UNITED STATES PATENT AND TRADEMARK OFFICE

Office Action Summary	Application No. 10/506,616	Applicant(s) NAAMAN, CHIBBI	
	Examiner Emily I. Nalven	Art Unit 3744

DETAILED ACTION***Priority***

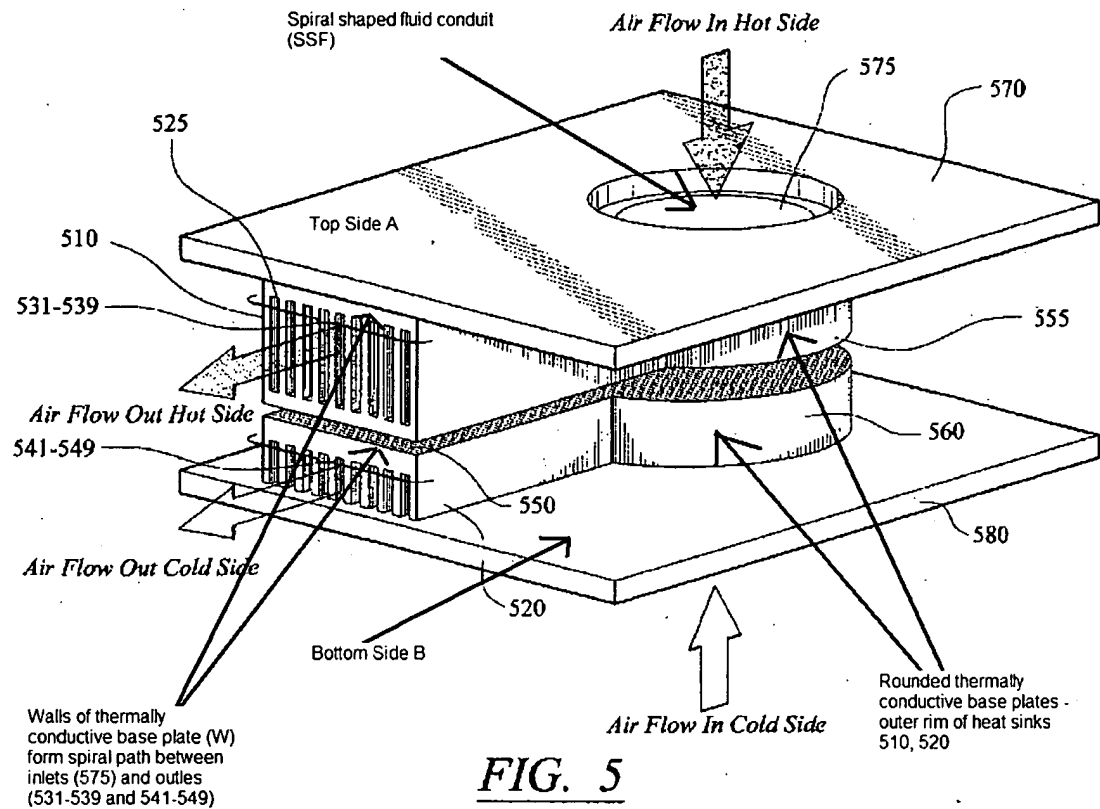
In regard to claim 10, Klett et. al. teach an apparatus (100) wherein the first fan (140) is positioned at a center of the spiral path (SSF) (see annotated Fig. 5 above). Fan 555 in annotated Fig. 5 above represents fan 140 from the first embodiment of this invention.

In regard to claim 13, Klett et. al. teach an apparatus (100) for use as a fluid conditioner for directing conditioned fluid to a specific location through a conduit (SSF) connected to the outlet (531-539 and 541-549) of the spiral shaped conduit (SSF) (see annotated Fig. 5 above and col 9 lines 35-40).

Klett et. al. also teach that when electric current is passed through the array (130) a temperature gradient is formed between the conditioned-air compartment (100) and the heat sink compartment (510, 520) (col 6 lines 33-40) and two fans (555 and 560) mounted opposite each other (see Fig.1 and annotated Fig. 5 above).

In regard to claim 15, Klett et. al. teach an apparatus (100) wherein the conditioned air compartment comprises a first heat transfer (510) unit fabricated from a thermally conductive material (col 6 lines 10-11), the heat transfer unit comprises a base plate and perpendicular walls (W) forming a spiral path (SSF) and wherein the first inlet (575A) and the first outlet (531-539) are located at the inner end and the outer end of the spiral path, respectively (see annotated Fig. 5 above).
